HOPE CREEK GENERATING STATION

AMENDMENT TO FACILITY OPERATING LICENSE

Amendment No. 88
License No. NPF-57

ATTACHMENT TO LICENSE AMENDMENT NO. 88

FIGURE 2.1.6.1.1

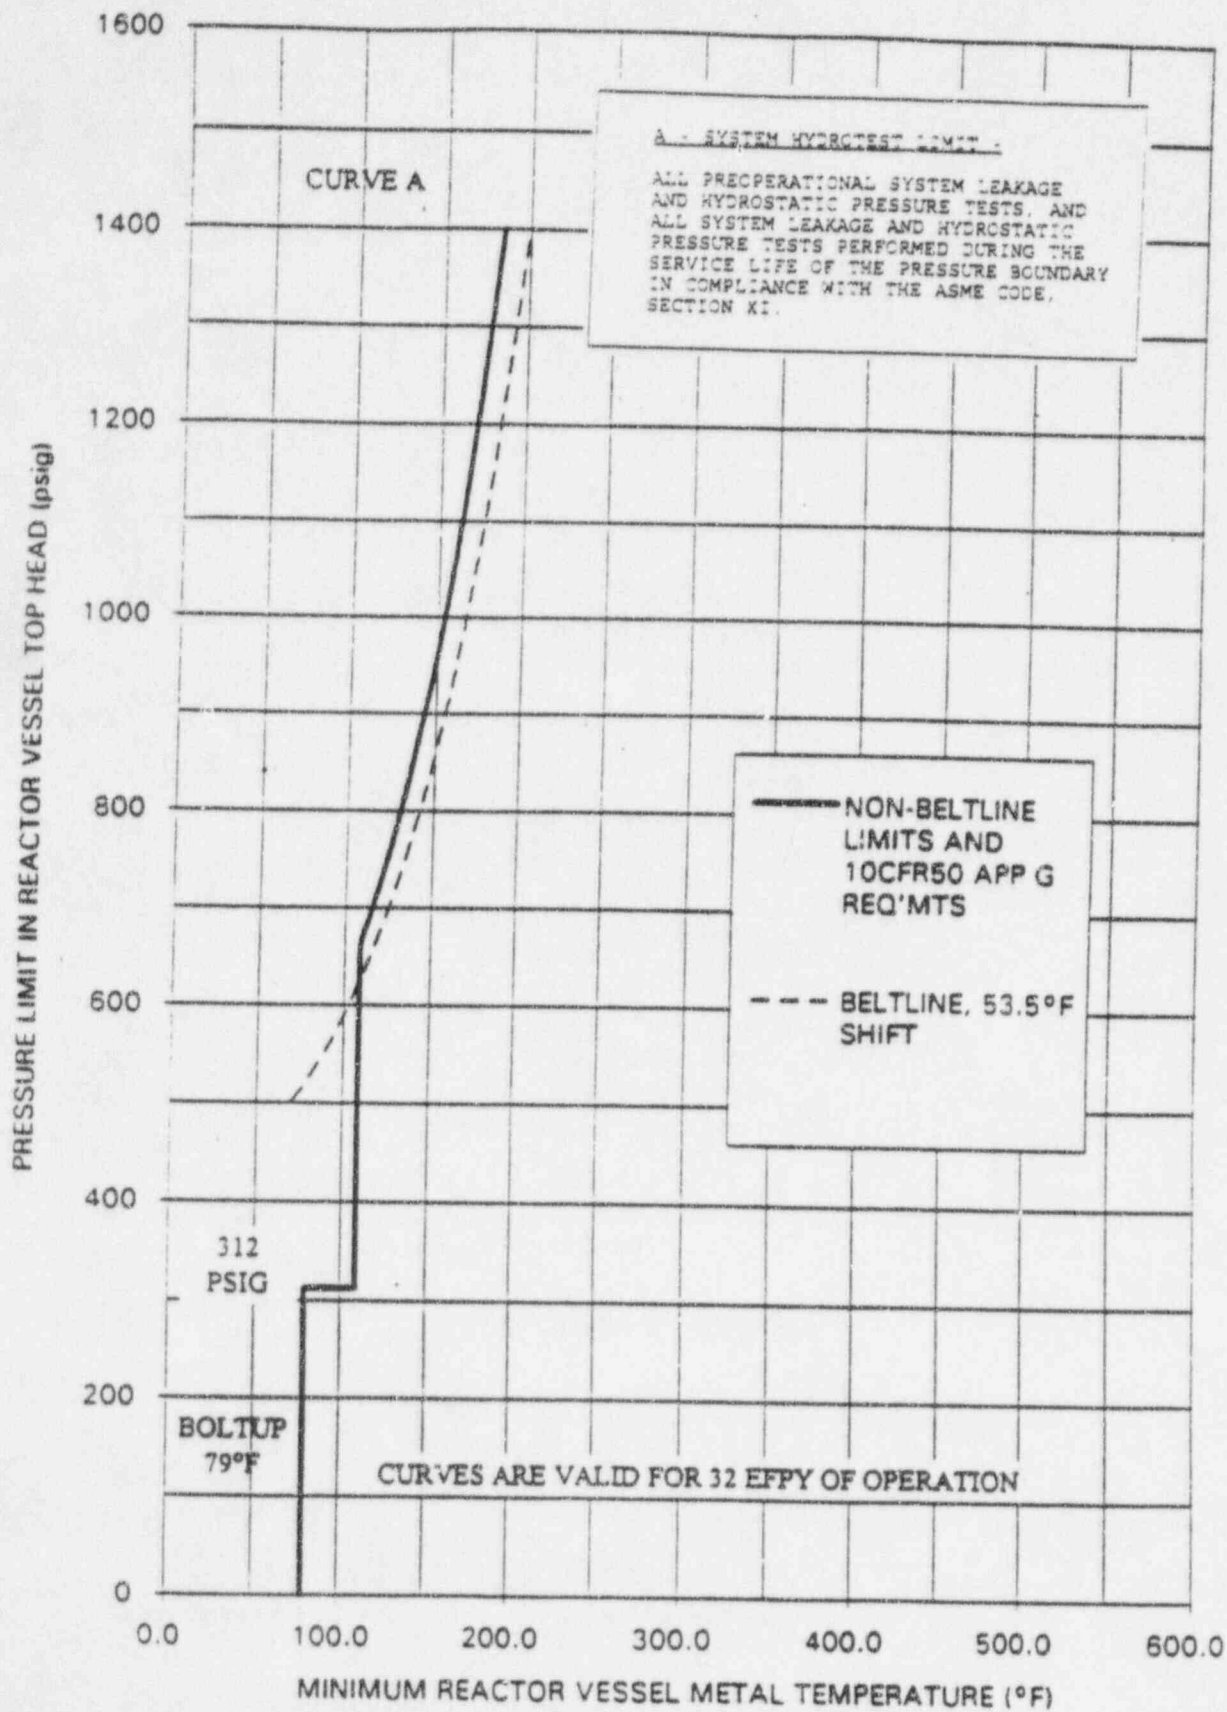
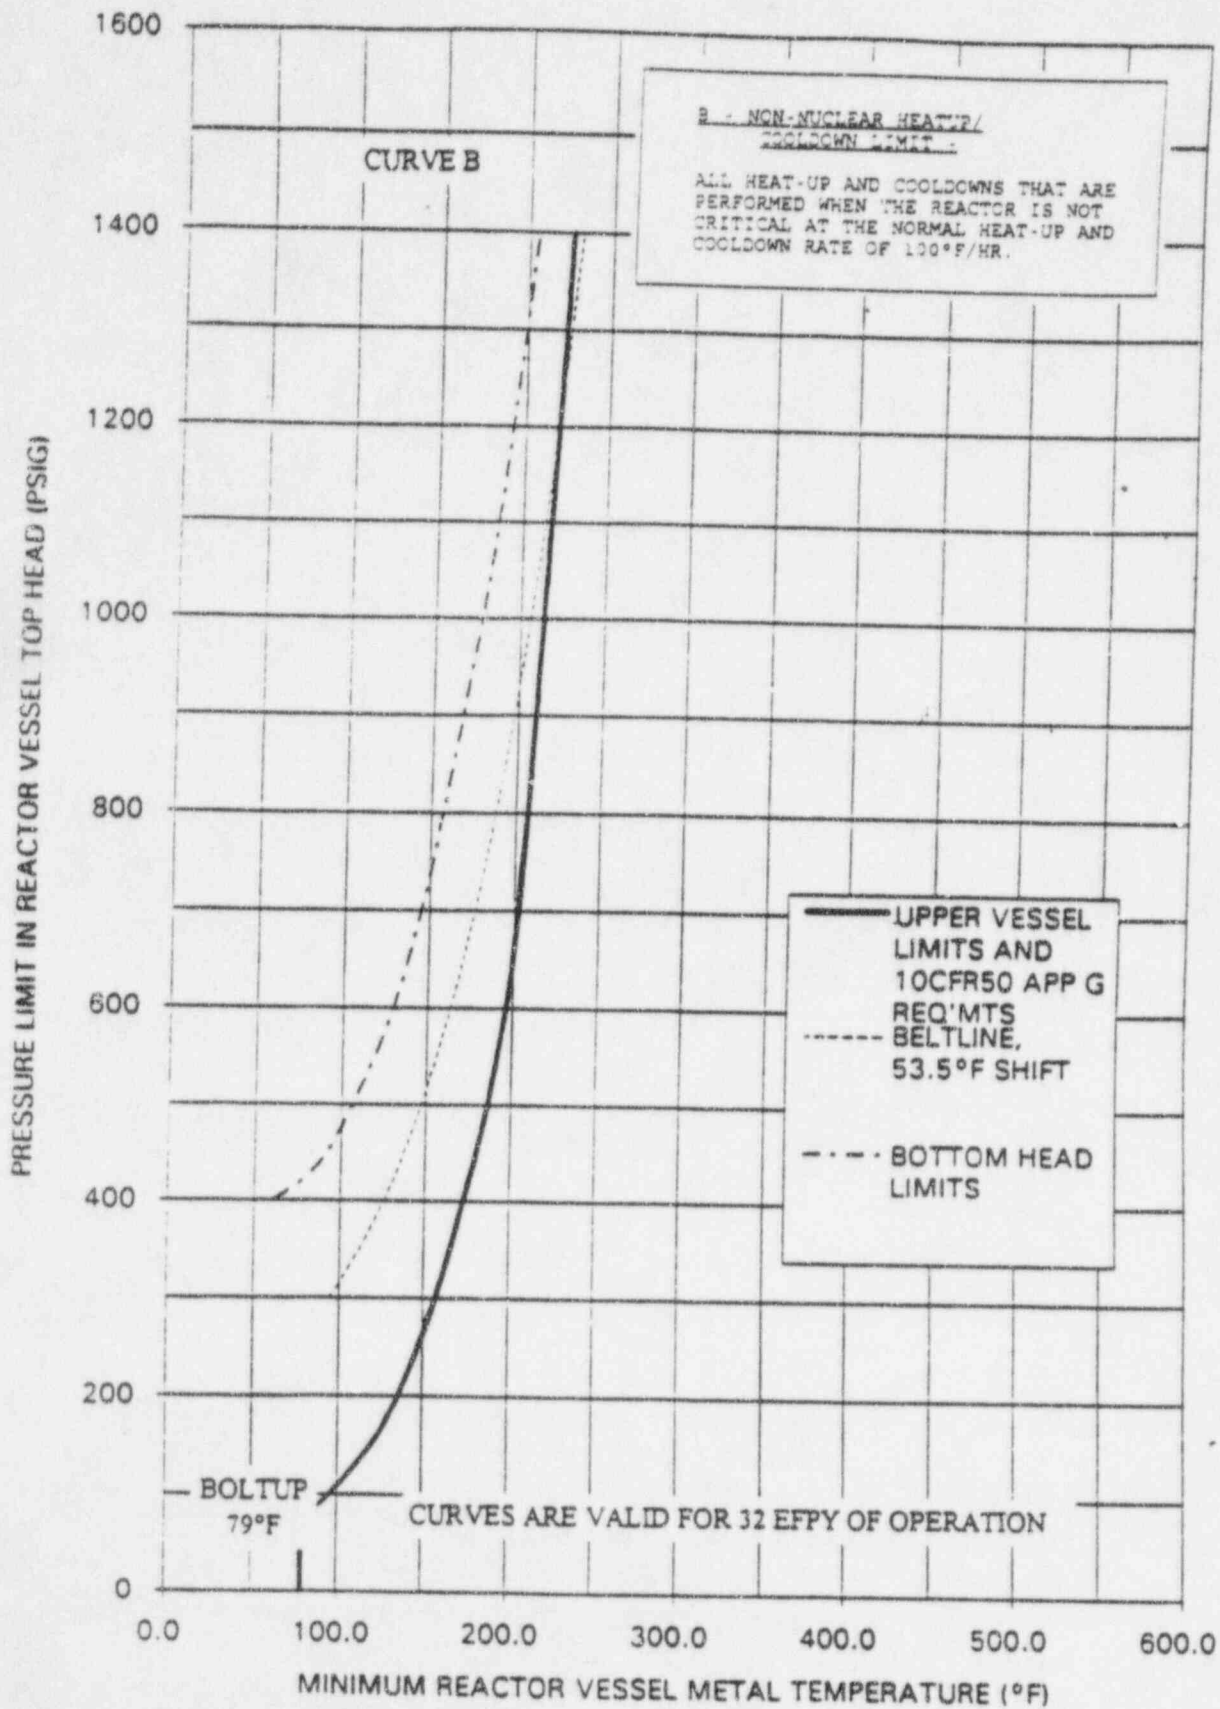
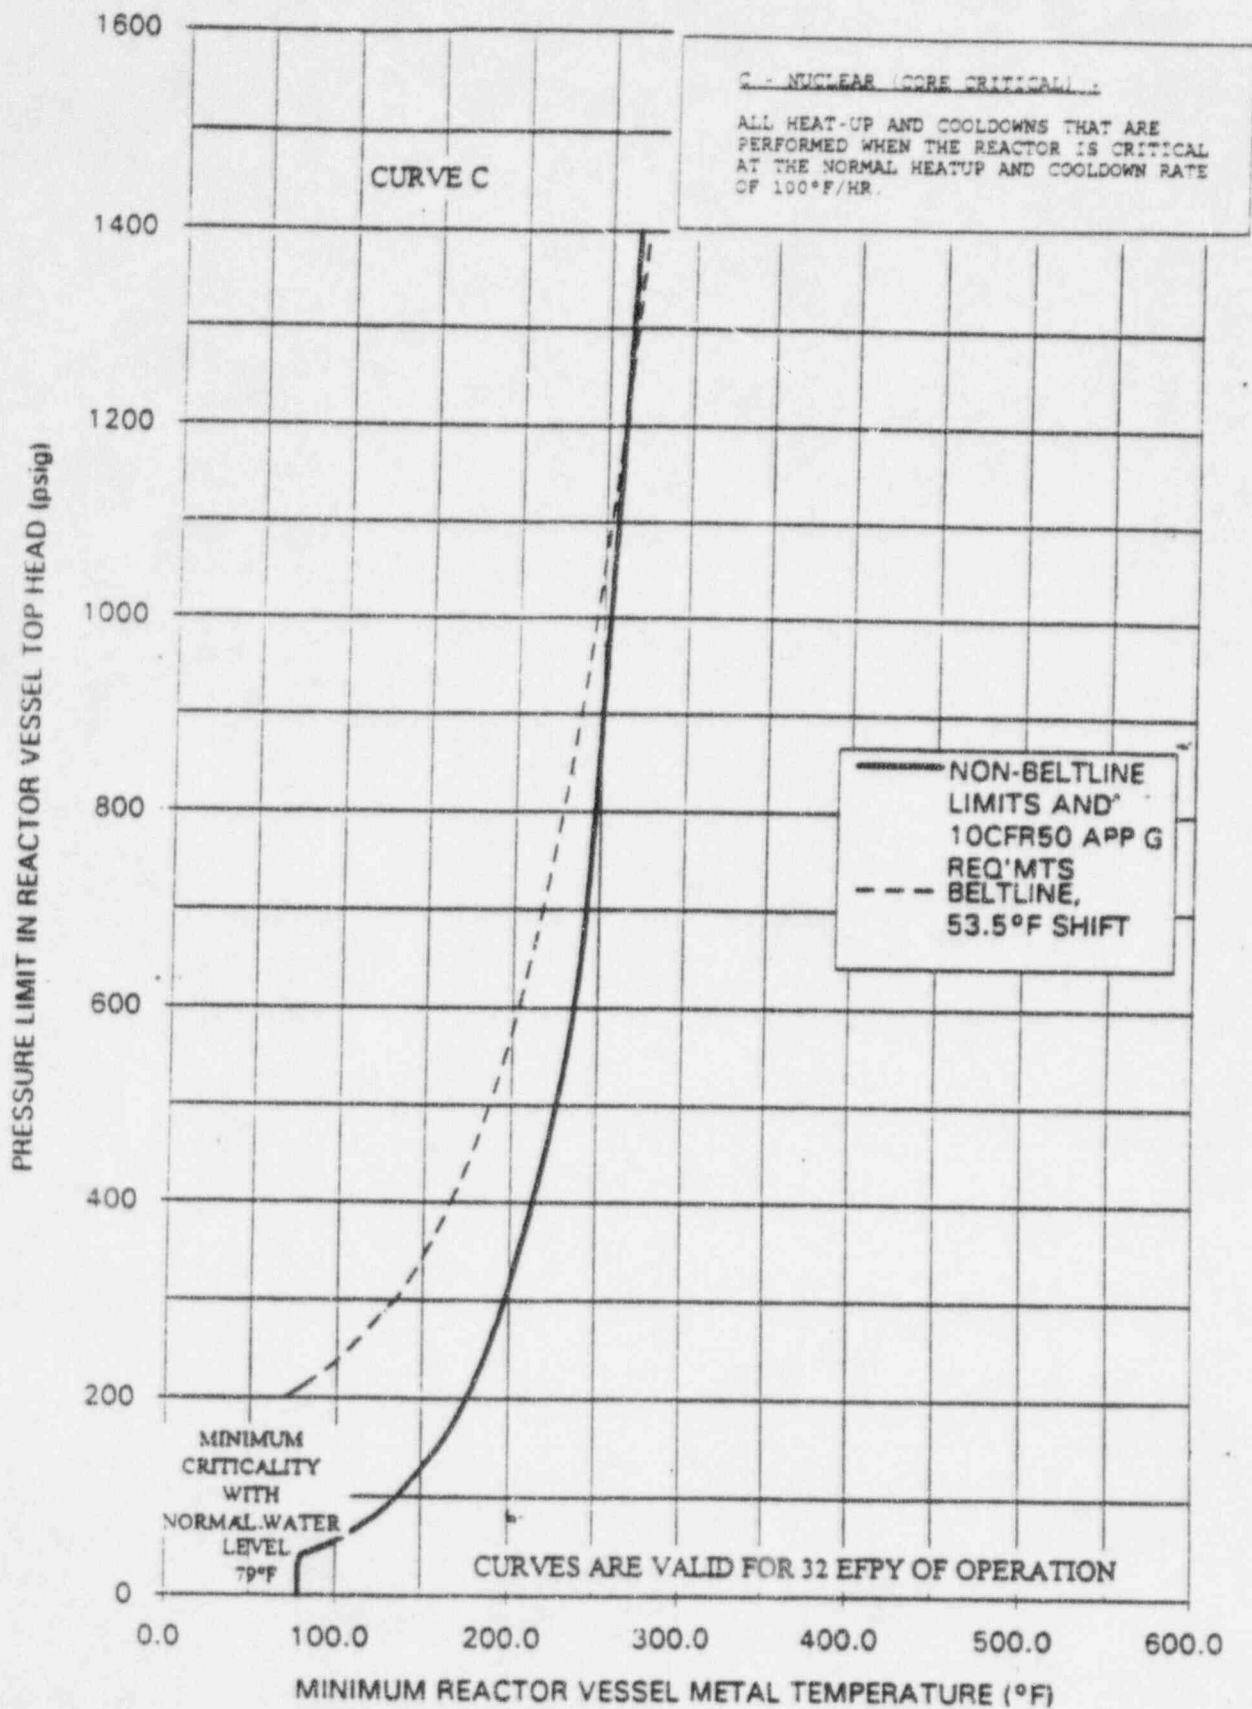
3.4.6.1 The reactor coolant system temperature and pressure shall be limited in accordance with the limit lines shown on Figure 3.4.6.1-1 (hydrostatic or leak testing), and Figure 3.4.6.1-2 (heatup by non-nuclear means, cooldown following a nuclear shutdown and low power PHYSICS TESTS), and Figure 3.4.6.1-3 (operations with a critical core other than low power PHYSICS TESTS), with:

4.4.6.1.1 During system heatup, cooldown and inservice leak and hydrostatic testing operations, the reactor coolant system temperature and pressure shall be determined to be within the above required heatup and cooldown limits and to the right of the limit lines of Figures 3.4.6.1-1, 3.4.6.1-2, and 3.4.6.1-3 as applicable, at least once per 30 minutes.

4.4.6.1.3 The reactor vessel material surveillance specimens shall be removed and examined, to determine changes in reactor pressure vessel material properties, as required by 10 CFR 50, Appendix H. The results of these examinations shall be used to update the curves of Figures 3.4.6.1-1, 3.4.6.1-2, and 3.4.6.1-3.
